## Dynamic Containment Terms and Conditions

### Amendment of EBGL Article 18 mapping to include Dynamic Containment Terms and Conditions requirements

EBGL Article 18 Dynamic Containment Terms and Conditions Consultation Responses summary

**Detailed response**

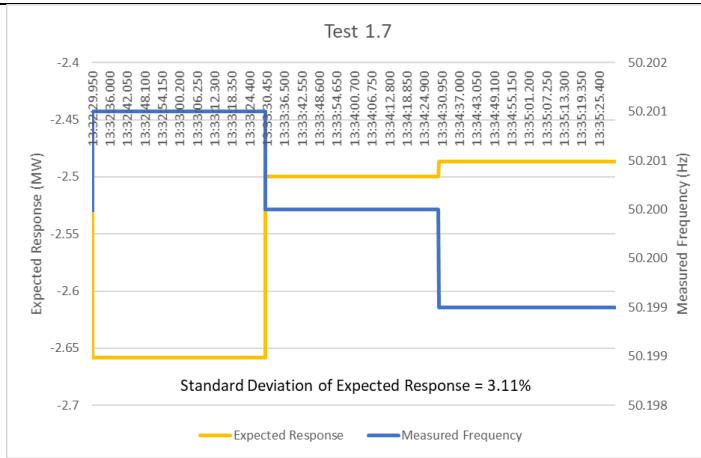
It is our view that the standard deviation pass/fail criteria in the DC Testing Guidelines Consultation Draft should be changed to be brought into line with the proposed changes made to the Allowable Power Tolerance.

Under the standard deviation pass fail criteria in the DC Testing Guidelines consultation draft the Allowable Power Tolerance for Test 1 has been relaxed to +-3% of maximum contracted power, however the pass criteria for standard deviation remains +-2.5% of expected active power response, which for certain tests can be challenging.

This is most apparent in tests 1.7 and 1.8, as these are at the knee point of the Dynamic Containment droop curve a small deviation in frequency measurement has a large effect on power. For example, for a 50MW plant, in test 1.7, the expected active power response is 2.5MW (5% of 50MW), and therefore the allowed standard deviation is 2.5% of 2.5MW, or 0.0625MW (62.5kW), which is equivalent to 0.13% of the maximum contracted power.

Additionally, the tightness of this standard deviation is such that in tests 1.7 and 1.8, the metering accuracy of the site alone can give results outside of the of the 2.5% tolerance, even with a meter that meets the DC Service Terms. For example, if a battery had no error in response or delay (which is of course impossible), then if the measuring error in the metering of the battery was 0.001Hz (as allowed under paragraph 15.5 of the DC Service Terms) and during the 3 minute test the measured frequency was at 50.201Hz for 1 minute, 50.2Hz for 1 minute and 50.199Hz for 1 minute, then the standard deviation of this test would be 3.11% and would fail the testing.

To address this, we suggest that the pass criteria for standard deviation is changed to +-2.5% of maximum contracted power, in line with the change to Allowable Power Tolerance.

time period of three minutes. We have now removed this from Test 1. We believe that now the assessment is more closely aligned with performance monitoring, tolerance bands will be used instead of Standard Deviation.
